DART SERVICE INSTRUCTION

TO AMEND INSTALLATION INSTRUCTIONS D350-607-2 REV. C AND EARLIER,
INSTALLATION INSTRUCTIONS D350-607-3 REV. A AND EARLIER, AND
INSTRUCTIONS FOR CONTINUED AIRWORTHINESS ICA-D350-607 REV. 4 AND EARLIER

A	NEW ISSUE	MB	13.06.06
REV.	DESCRIPTION	BY	DATE
DESIGN		DART AEROSPACE LTD	
DRAWN		HAWKESBURY, ONTARIO, CANADA	
CHECKED		DRAWING NO.	REV. A
MFG. APPR.		DSI 9657	SHEET 1 OF 2
APPROVED		TITLE	SCALE
DE APPR.		WASHER CHANGE	NTS
DATE	13.06.06	COPYRIGHT © 2013 BY DART AEROSPACE LTD THIS DOCUMENT IS PRIVATE AND CONFIDENTIAL AND IS SUPPLIED ON THE EXPRESS CONDITION THAT IT IS NOT TO BE USED FOR ANY PURPOSE OR COPIED OR COMMUNICATED TO ANY OTHER PERSON WITHOUT WRITTEN PERMISSION FROM DART AEROSPACE LTD.

**FIGURE 1: D3915-041 LONG BASKET LID ASSY (LIGHT WEIGHT)
D4019-041 SHORT BASKET LID ASSY (LIGHT WEIGHT)**

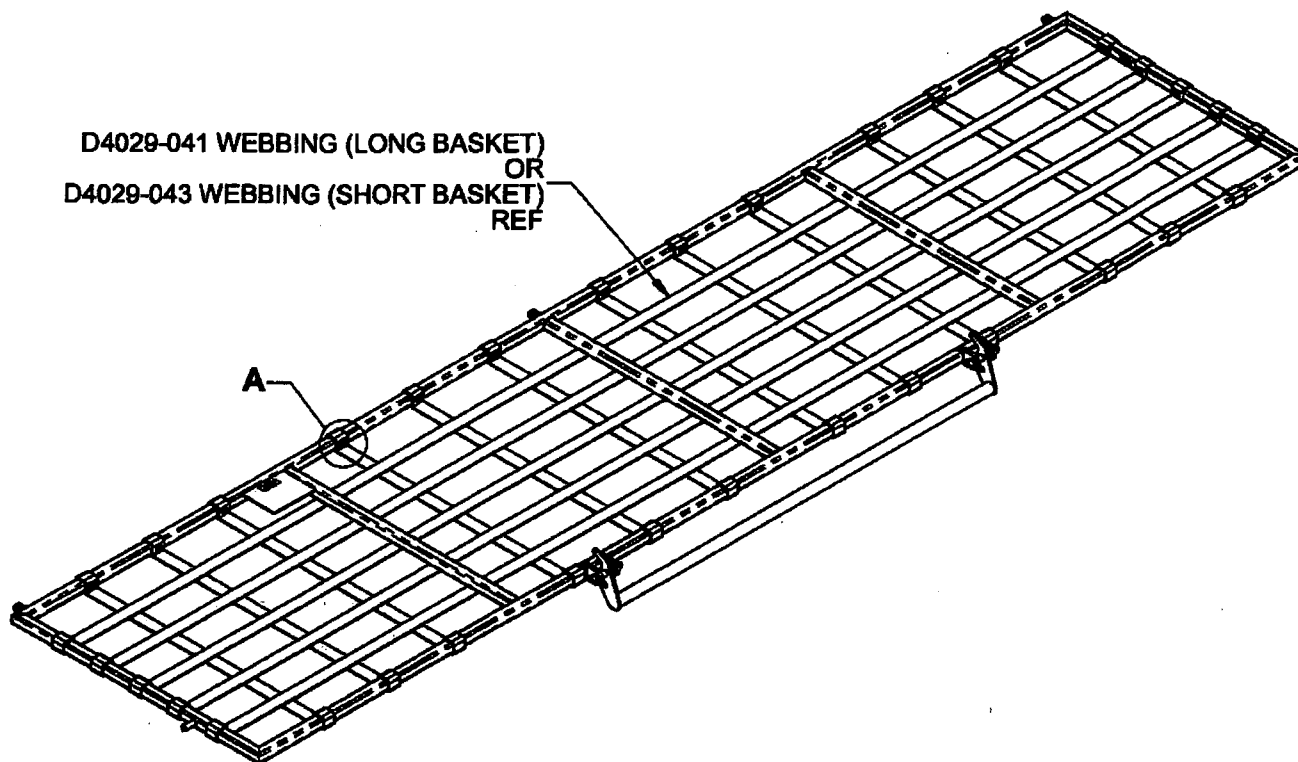
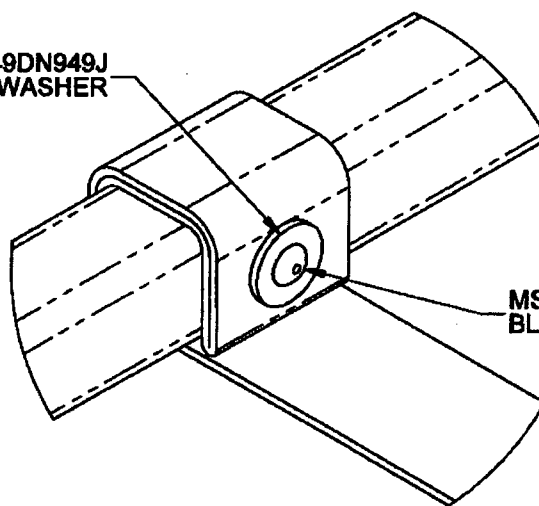
It has come to DART's attention that the webbing strands of the cargo net riveted to the structure of the lightweight lids on D350-607-443/-447/-543/-547 Heli-Utility-Baskets at CHG 004 and earlier may pull through the small washer and rivet head and detach during operation.

The purpose of this service instruction is to provide parts and instructions to replace the NAS1149DN416J Washers and MS20600AD4W3 Rivets fastening the webbing strands of the cargo net onto the structure of the lightweight lids with NAS1149DN949J Washers and MS20600AD4W4 Rivets.

2.4 Re-install the webbing as shown in Figure 1 of this service instruction

NAS1149DN949J
WASHER

MS20600AD4W4
BLIND RIVET

DETAIL A: RIVET/WASHER REPLACEMENT

34 PL ON D3915-041, 30 PL ON D4019-041
